# CITY OF ALBUQUERQUE

**RE: Sunset Gardens Subdivision (File: K12D003)**  
**Drainage Report, Engineer's Stamp Date 1-19-15**  
**Grading and Drainage Plan, Engineer's Stamp Date 5-15-15**  
**Superseded by Grading and Drainage Plan, Engineer's Stamp Date 6-23-15**

**RE: Revised Grading Plan (K12-D003)  
Sunset Villa  
Albuquerque, New Mexico**

**RE: Sunset Gardens Subdivision (File: K12D003)**  
**Grading and Drainage Plan, Engineer's Stamp Date 1-19-15**  
**Drainage Report, Engineer's Stamp Date 1-16-15**

ENGINEER'S SEAL	SUNSET VILLA	DRAWN BY WCWJ
		DATE 5-15-15
	GRADING AND DRAINAGE PLAN	21401-LAYOUT-1-06-13
5/15/15	 <i>Rio Grande Engineering</i> 1606 CENTRAL AVENUE SE SUITE 201 ALBUQUERQUE, NM 87106 (505) 872-0999	SHEET # 6 OF 24
DAVID SOULE E. #14522		JOB # 21401

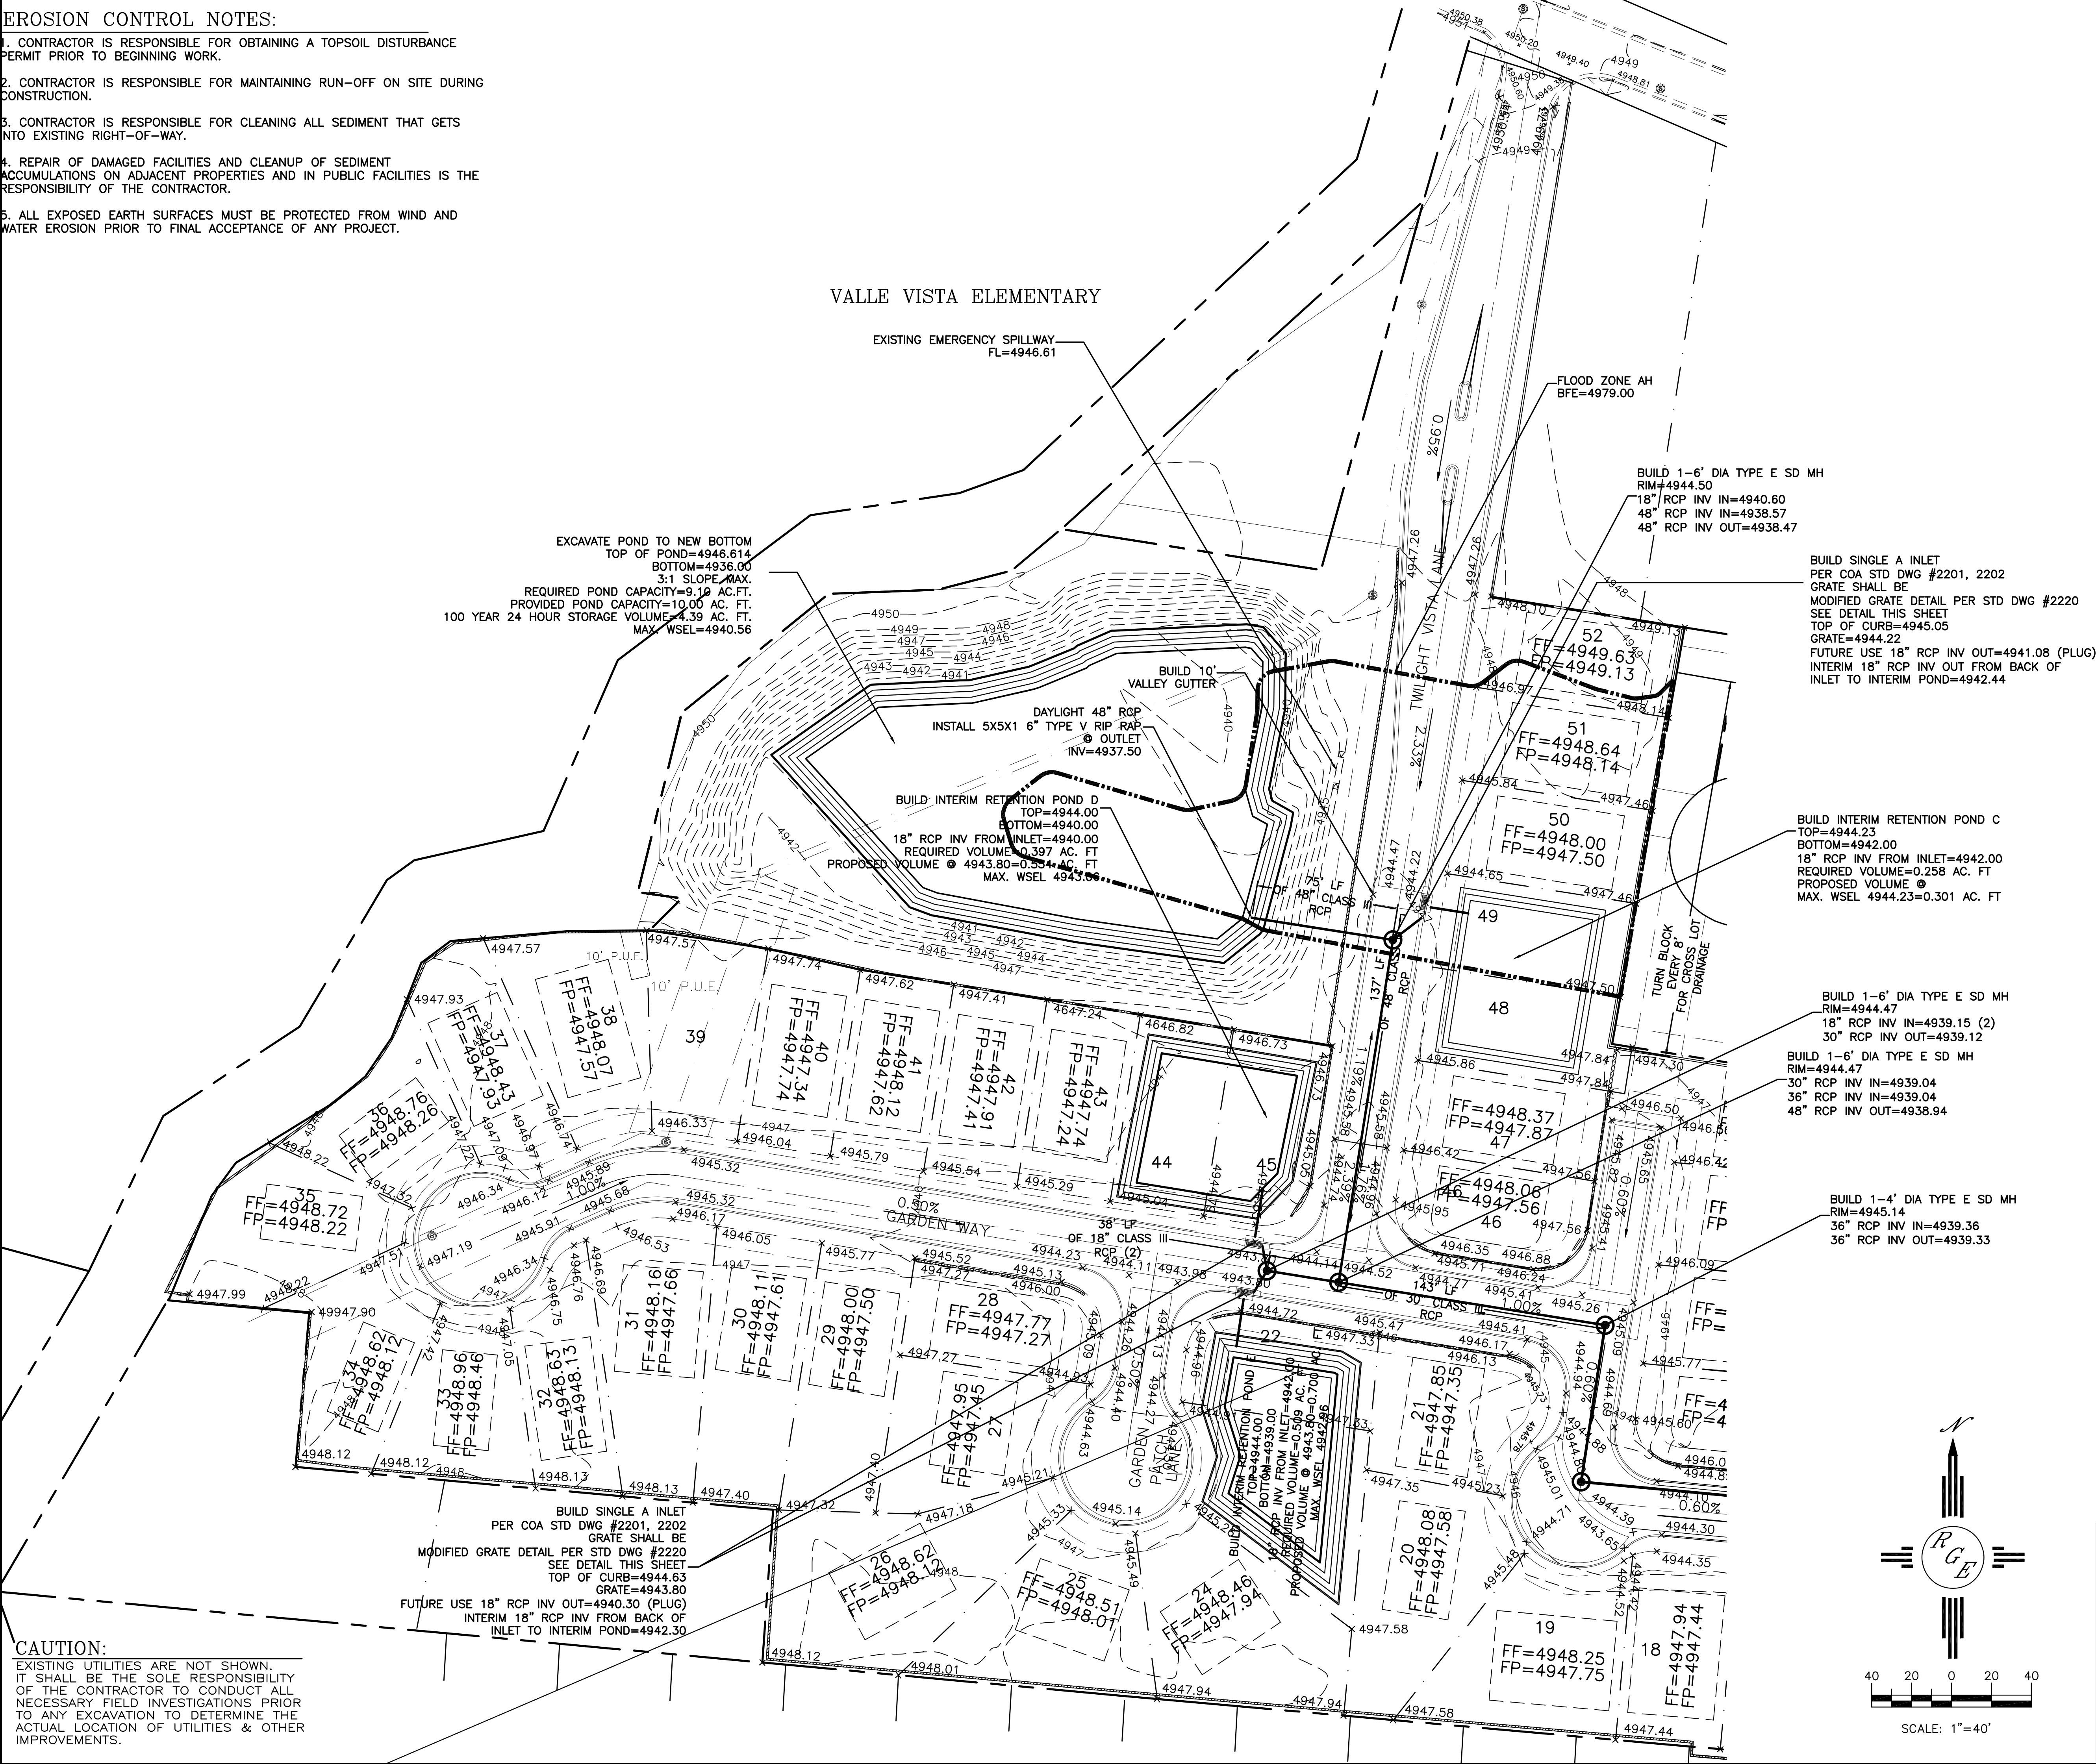
1. Correct the Lot numbers to match the plat, particularly Lots 46-52
2. G&D dated 6-23-15 does not have existing contour labels (older submittal does)
3. Correct the BFE Elevation (FIRM says 4947)

4. Label and Correct all the SD pipe sizes along Garden Way. Series should be 30", 36", 36", and 30".
5. Show and Label the irrigation and 10' utility easement thru Lots 68 and 5 ( not on 6-23-15 submittal- but is shown on the 5-15-15 submittal)

6. Specify the elevation of the turned block on wall along Lots 46-50 so that the BFE will equalize within the present flood zone boundary.
7. Legal Description, Benchmark, Datum are not shown on the plan (The property line along Tract A (the roadway tract) should be the same line type as the property line between lots.

8. Address "First Flush" with a statement. (it was on the 5-15-15 plan but not on the later one)
9. Show existing flow line elevations in Powell where new construction ties to existing. (show also on Work Order)

10. It is noted that the Emergency Spillway for each pond is the inlet grate. Do you mean that the pond will surge back to the inlet?
11. Wall hatching is inconsistent with legend. Also, some walls not hatched at all, but only on the latest submittal.

12. Inlets into all the Ponds: (shown also on Work Order)
  - a. the invert at pond is higher than invert at inlet
  - b. the Top of Curb is 1.43' higher than the grate elevation for Ponds A,B

- c. The Grate Elevations shown are the Flowline elevations

13. Invert elevations of the 18" dia. into pond is about 1.5' above the Max. allowed invert elevation per detail 2202, Note B. Invert is also higher than "future use" invert. Hydrology would prefer for the inverts into pond to be lower than the "future use inverts." When the inverts to the pond are plugged in the future, lean fill can be poured to slope the bottom of the inlet to the "future use" invert. A special detail will need to be on the work order and G&D plan. Provide the detail on the G&D for future reference.
14. The Pond elevations and capacities do not match that shown in the report
15. Max WSEL for the ponds indicate that there is not sufficient freeboard.

Based upon the information provided in your submittal received 1-20-15, the above referenced submittal cannot be approved for action by the DRB on the Preliminary Plat and for Building Permit until the following comments are addressed:

1. Temporary ponds cannot be on lots and must be on tracts. Therefore you will have to come in through DRB to amend the plat and revise the infrastructure list. ✓

2. A LOMR-F will need to be on the I.L. ✓
3. For a LOMR-F you will need to provide compensatory volume. Where do you intend to provide this extra volume? Provide Volume calculations.

4. Lots 68 and 5 have an irrigation and utility easement thru them which should be shown on the Grading Plan. The pad crosses the easement. All easements should be shown on grading plan, including the utility easement. ✓

5. Roadway tracts will need to have drainage easements. ✓
6. Show the flood zone on the plan. A Flood plain permit will be required.
7. You may need to remove the wall, or provide opening in the wall behind lots 46 thru 49 so that the BFE will equalize within the present flood zone boundary. Once the pond is removed in the future, there needs to be some means of equalizing the BFE of the flood zone.

8. Provide a Benchmark and Datum.
9. If Lot 39 is owned by County, note so, and remove pad.
10. The dashed line along the roadway tract – is this the property line? If so, it is not in the same line type as the property line.

11. Show lot numbers on Grading Plan
12. On each pond indicate the Emergency Spillway and the MWSEL
13. The Land Treatments (A,B,C,D) do not add up to 100%.

14. Address "First Flush" with a statement.

1. We have submitted platting action to consolidate the lots for each pond. The approval of this plan is a requirement for that action
2. A LOMR-F is on the amended infrastructure list

3. Due to no fill being placed below the base flood elevation, there is no compensatory volume. All spots are above this flood plain.
4. All easements of record have been shown on the grading plan

5. We attempted to add this easement on the plat but drb wanted it as a separate easement. We have attached exhibit A for this easement.
6. We have shown flood zone on the plan

7. We have added turned blocks every 8' to allow flood waters to safely pass thru wall
8. We have added benchmark and datum to plan
9. Lot 9 is owned by the county and the pad has been removed

10. We have corrected the line type for the property line
11. We have added lot numbers to the plan
12. The have added the note to the plan identifying the inlet grates as the pond overflows, and added the MWSEL to each pond

13. We have corrected the weighted E land treatment table
14. We have added note to the plan regarding the first flush

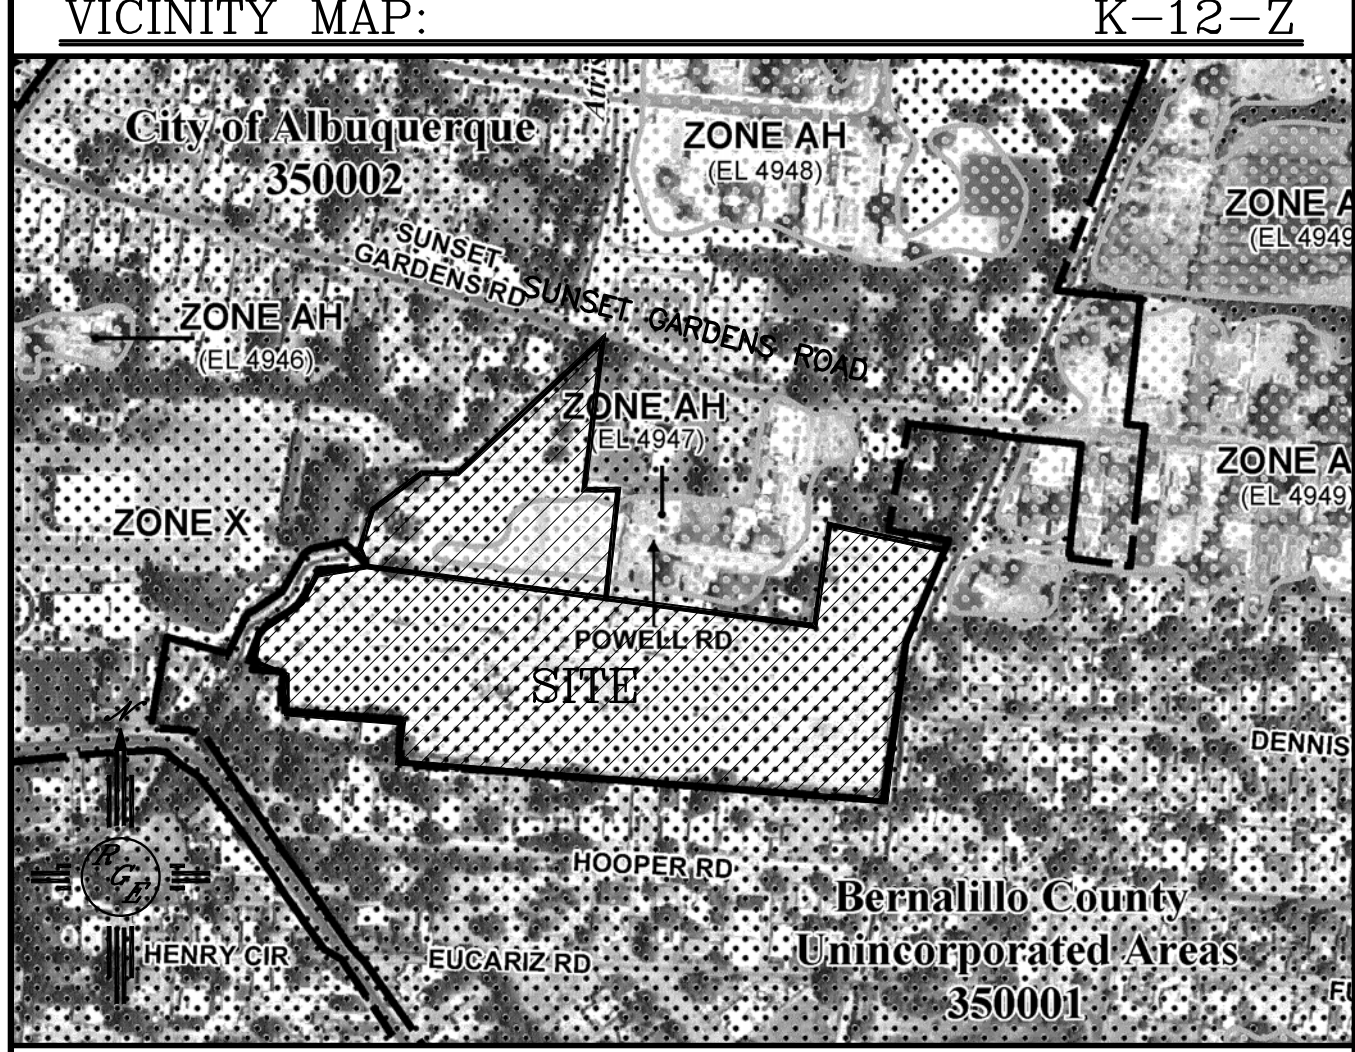
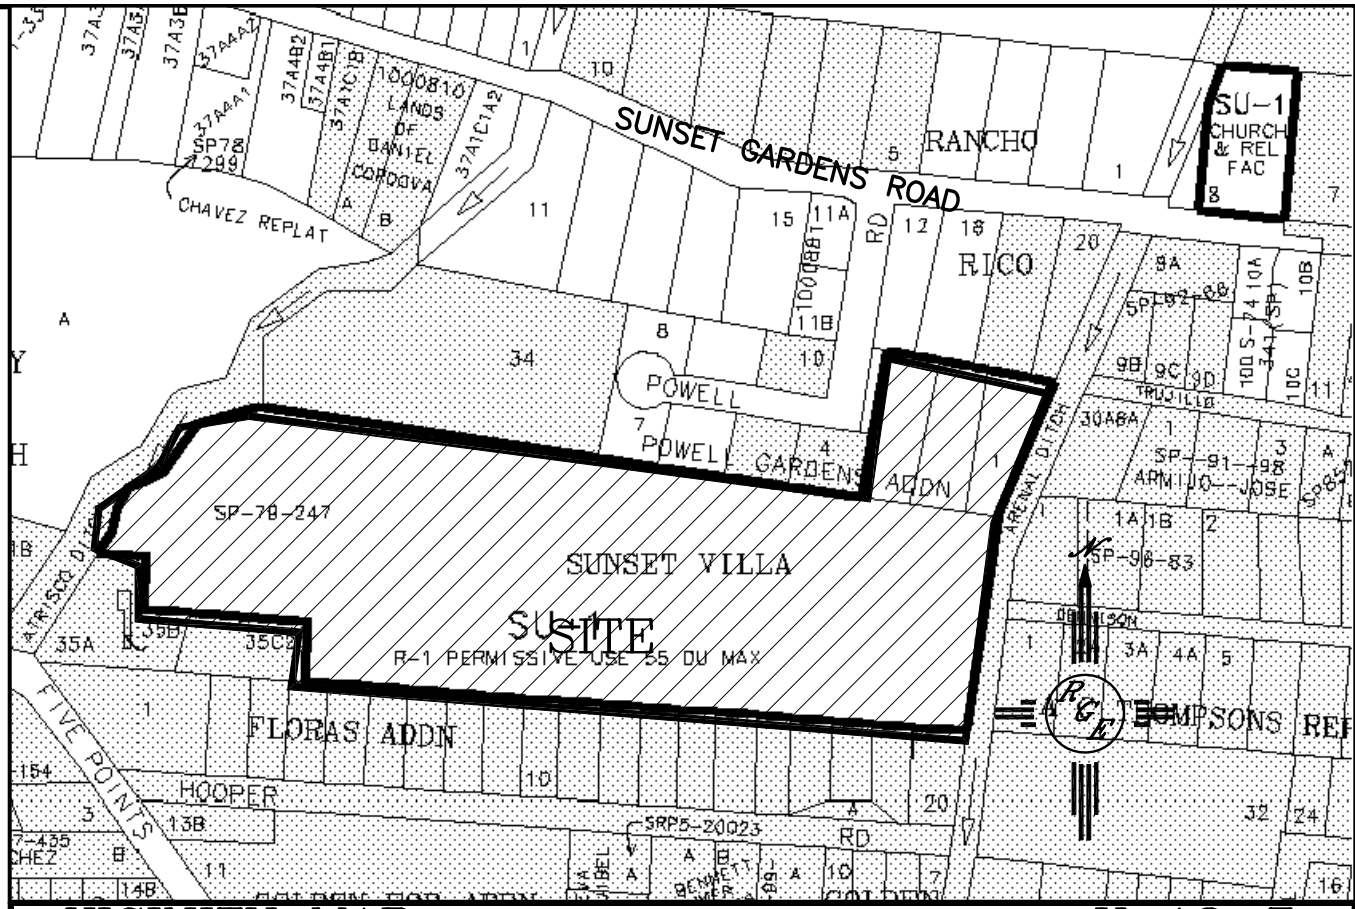
2. Near the Powell entrance, show the existing wall is to be removed, and the extents of the removal since it appears some wall is to remain. (show also on Work Order)

3. Hatch pattern for proposed and existing walls are not reflected on plan.
4. Show existing flow line elevations in Powell. (show also on Work Order)
5. Calculations for Type-A inlet uses Area = 5.92 sq.ft. However, I calculate 3.84 sq. ft.

6. If inlet is in sump condition, state so. Sump catch basins need to be designed for 2x 100yr storm, or other criteria in DPM pg 22-154.
7. Inlets into all the Ponds: (shown also on Work Order)

- a. the invert at pond is higher than invert at inlet
  - b. the Top of Curb is 1.43' higher than the grate elevation for Ponds A,B
  - c. The Grate Elevations shown are the Flowline elevations

- d. Invert elevations of the 18"dia. into pond is about 1.5' above the Max. allowed invert elevation per detail 2202, Note B. Invert is also higher than "future use" invert. Hydrology would prefer for the inverts into pond to be lower than the "future use inverts." When the inverts to the pond are plugged in the future, lean fill can be poured to slope the bottom of the inlet to the "future use" invert. A special detail will need to be on the work order and G&D plan.

1. We have labeled Sunset Gardens on the vicinity map
2. We have identified the removal of wall encroaching into the roadway
3. All of the walls are existing
4. We have shown flow line elevations for Powell
5. We have updated the type a inlet area
6. We have accounted for 2x the flow due to sump condition and increased 3 of the

inlets to double grates

7. A. We have corrected the pond inverts
- B. We have corrected the top curb elevations
- C. The grates are identified as flow lines
- D. we have modified the inlet so lean fill is placed to direct flow to interim ponds
8. We have made change to the work order and will be submitting to drc.
